ADSP-21477, 21478, 21479 88-Ld LFCSP & 100-Ld LQFP_EPad Package Outline Drawing Updates

May 22, 2013

CP-88-5 (88-Ld LFCSP) Updated Package Outline Drawing for ADSP-21477/21478/21479 Rev C

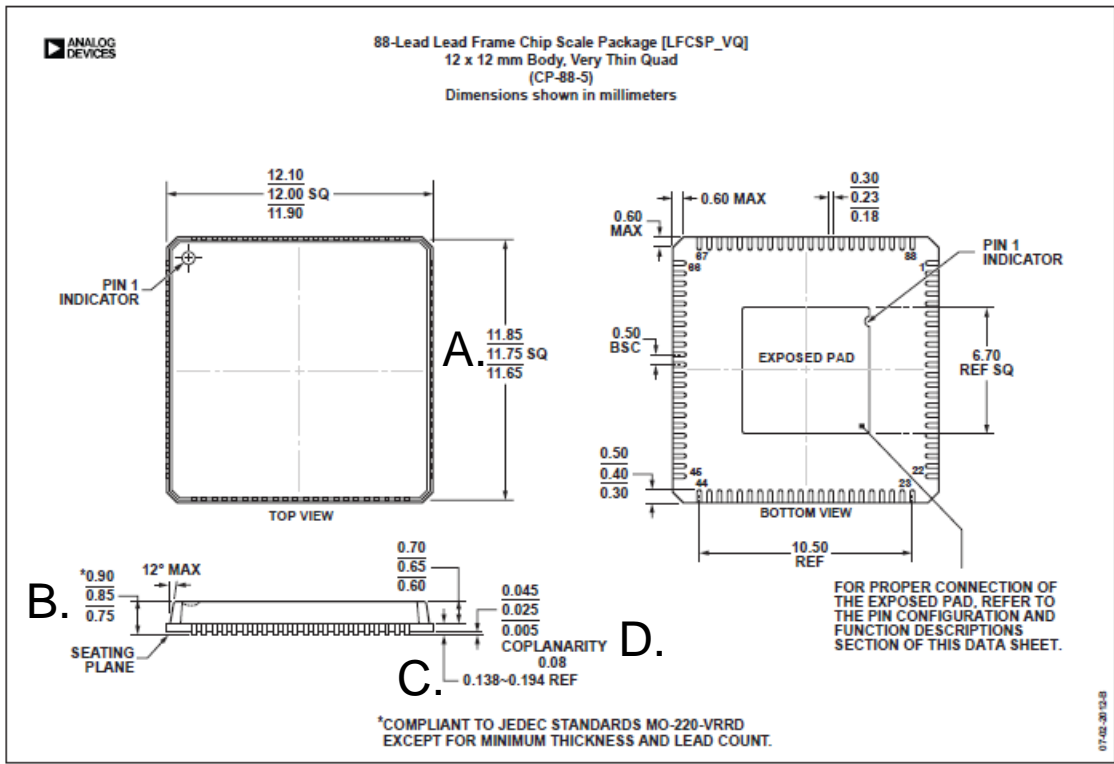
A.
 Previous: 12.10, 12.00, 11.90.
 Updated: 11.85, 11.75, 11.65.

B.
 Previous: 0.85, 0.80, 0.75
 Updated: 0.90, 0.85, 0.75.

C.
 Previous: 0.139-0.194 Ref.
 Updated: 0.138-0.194 Ref.

D.
 Previous: Not reported.
 Updated: 0.08 Coplanarity

SW-100-2 (100-Ld LQFP_EP) Updated Package Outline Drawing for ADSP-21477/21478/21479 Rev C Data sheet

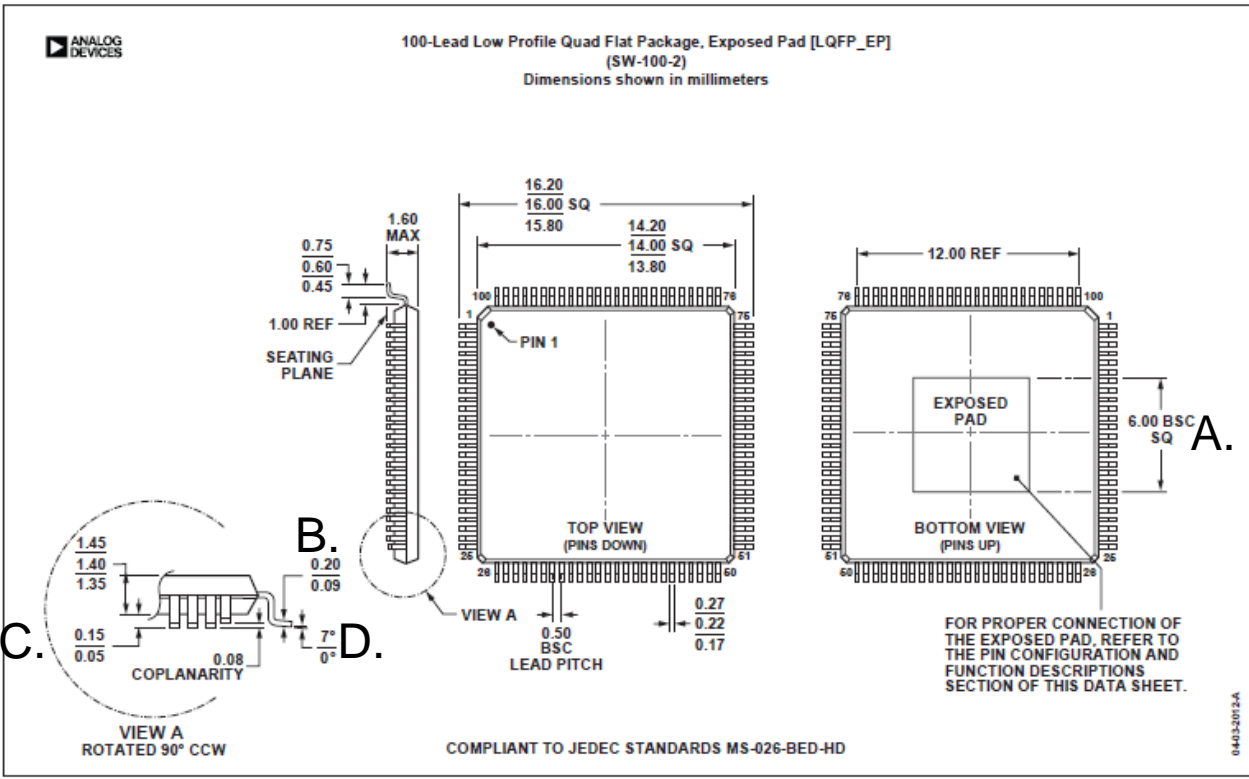
- A. Previous: 6.00 Ref SQ
Updated: 6.00 BSQ SQ
- B. Removed 0.15 Nominal dimension
- C. Removed 0.10 Nominal dimension
- D. Removed 3.5 Nominal dimension
